8111090642 731107
PDR ADDCK 05000247
P PDR

Change No. 4

Item No. 2

A change in the definition of the "Cold Shutdown Condition" (Item 1.2.1 on Page 1-1) is requested.

CORPORATE ORGANIZATION

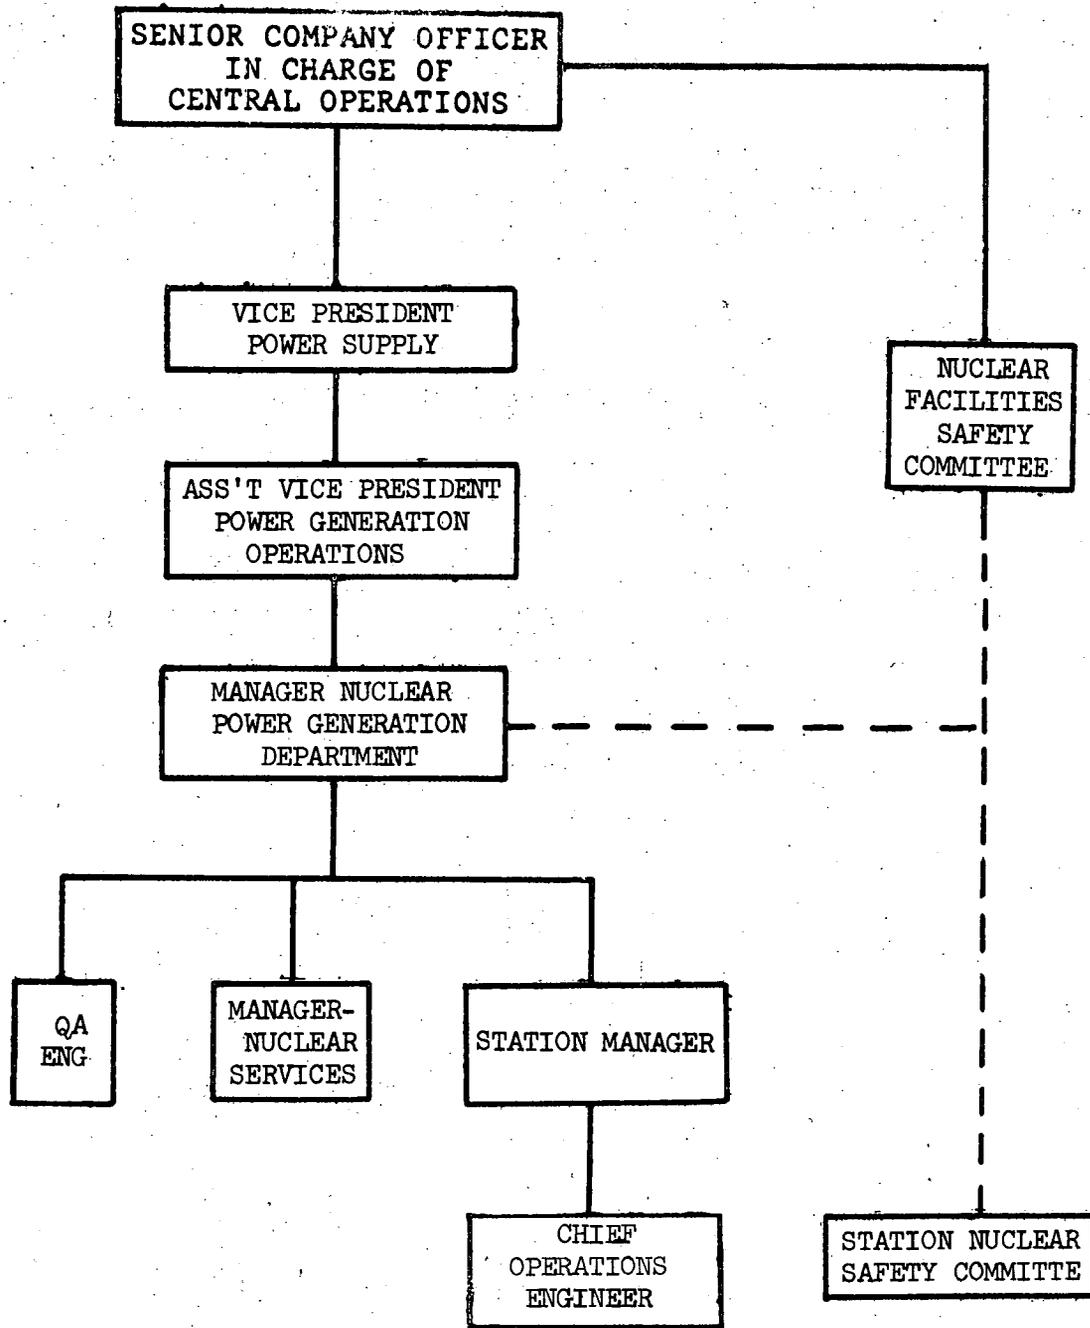
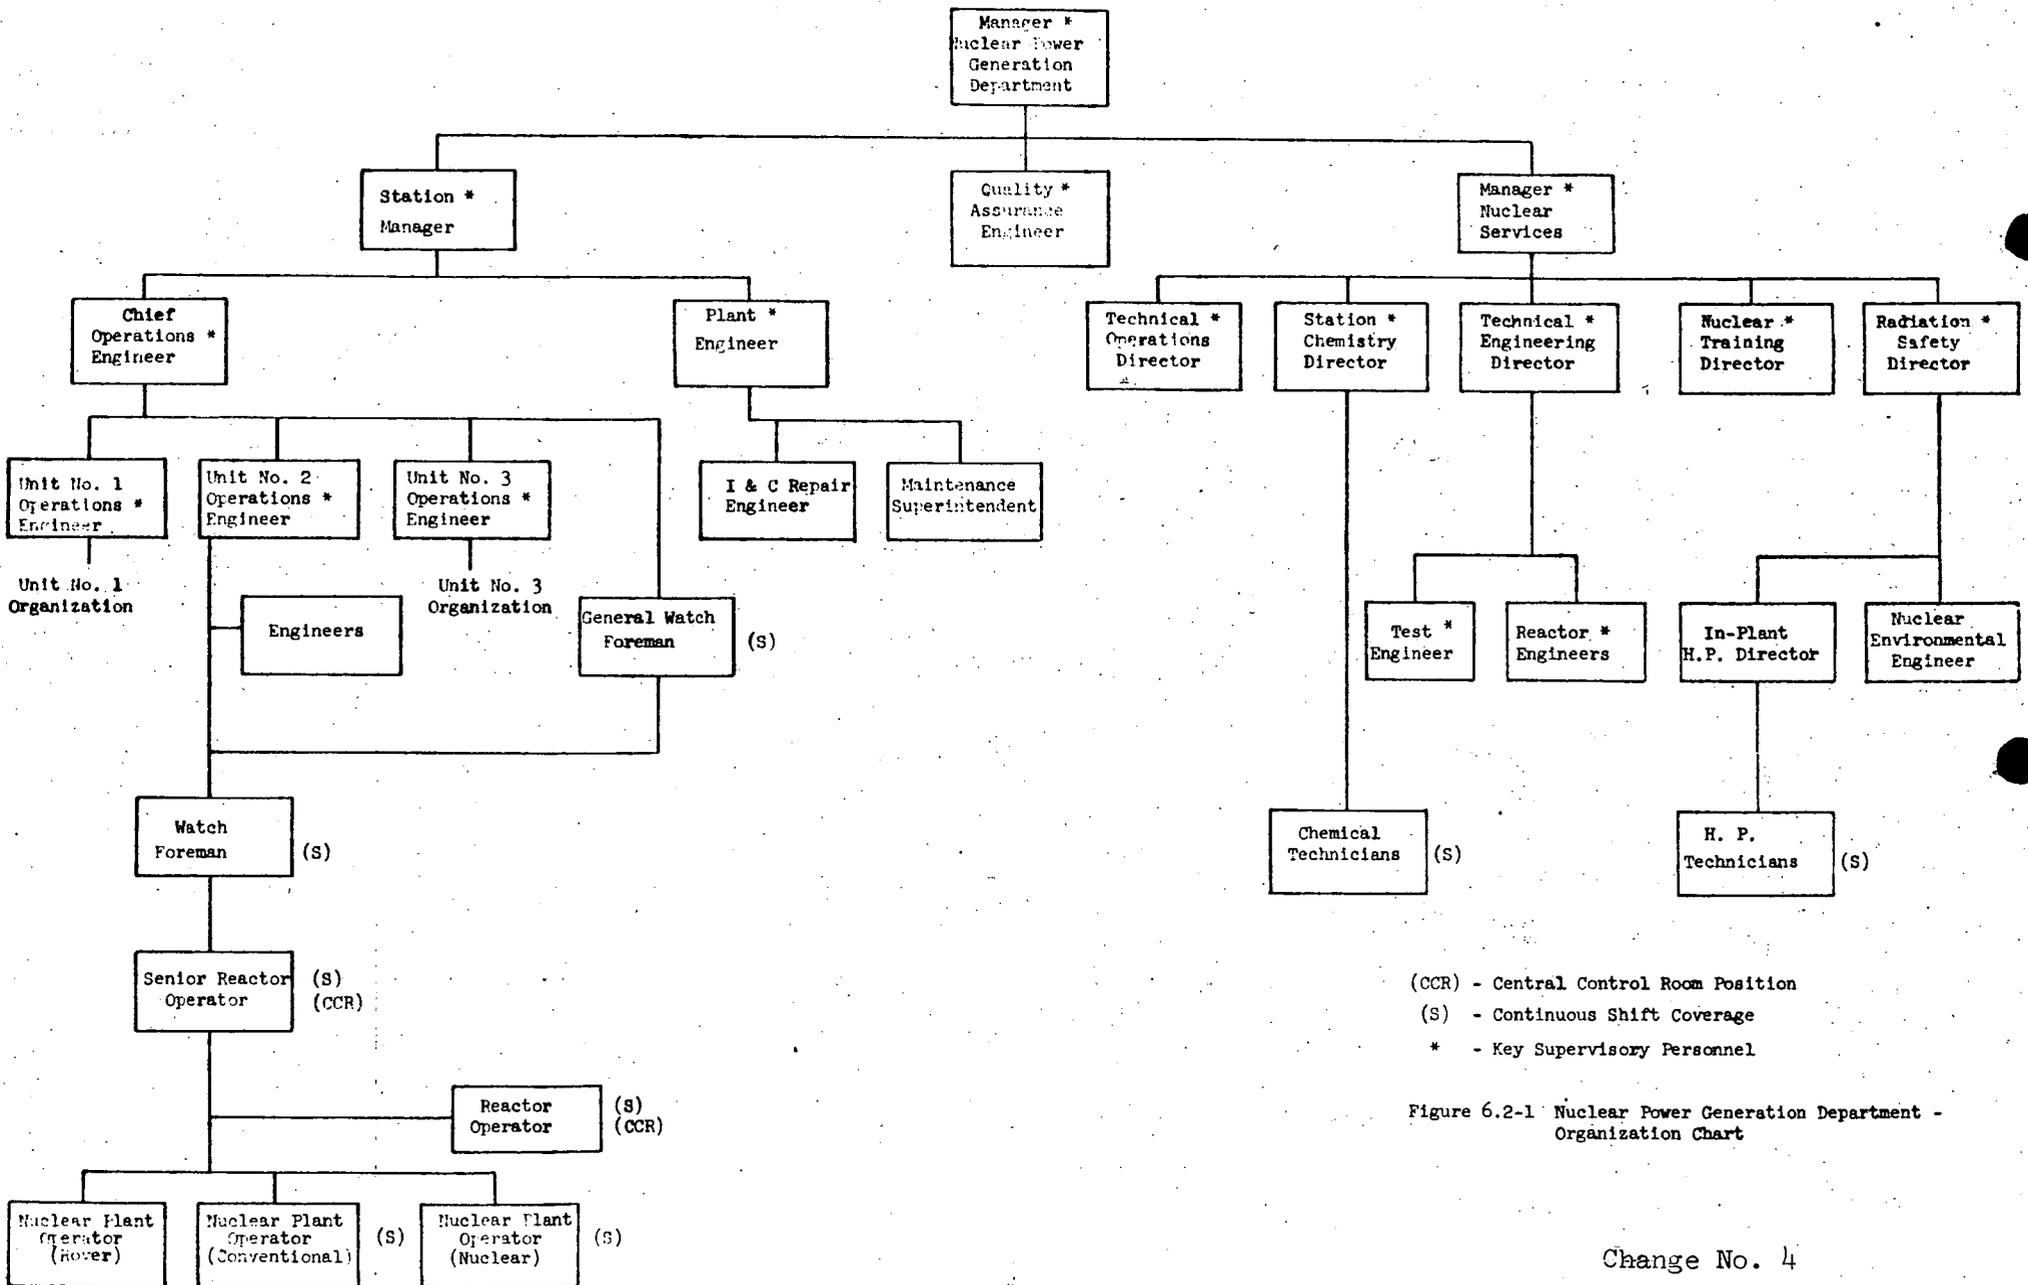
Consolidated Edison requests a rewording of the parts of Section 6 (Administrative Controls) that involve the organization of the Nuclear Power Generation Department. Because of a planned reorganization of this Department, revisions or additions of Pages 6.1-1, 6.1-2, 6.1-3, 6.2-2, 6.5-1, Figures 6.1-1 and 6.2-1 are requested. These changes would specify the positions of the persons responsible for operations of the plant and provide for notification to the Director of Licensing and the Director of Region 1 Regulatory Operations Office of any further reorganizations.

- 6.1.6 In all matters pertaining to operation of the nuclear facility, and to these Technical Specifications, the Chief Operations Engineer shall report to and be directly responsible to the Station Manager who, in turn, shall report to the Manager, Nuclear Power Generation

Department, as indicated on the corporate management organization chart of Figure 6.1-1.

6.1.7 Changes to the corporate management organization as shown in Figure 6.1-1, may be made without prior Commission approval. A written report describing such changes shall be forwarded within thirty (30) days of each such change to the Directorate of Licensing and to the Director of the Region I Regulatory Operations Office.
